TN_176

LC231X Errata Technical Note

Version 1.0

Issue Date: 2018-08-17

Figure 3 - Silkscreen Topside

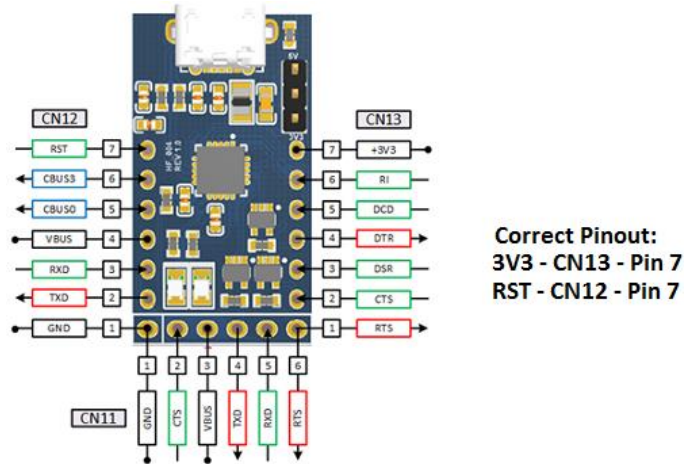
The LC231X module's bottom silkscreen text is located at wrong place.

The current silkscreen text "RST" and "VCCIO" should be at opposite locations. The "VCCIO" label should be "3V3".

1. Use the latest revision (Rev.1.1) of LC231X which have correct bottom layer silkscreen
2. Follow this errata to connect the LC231X module to their application
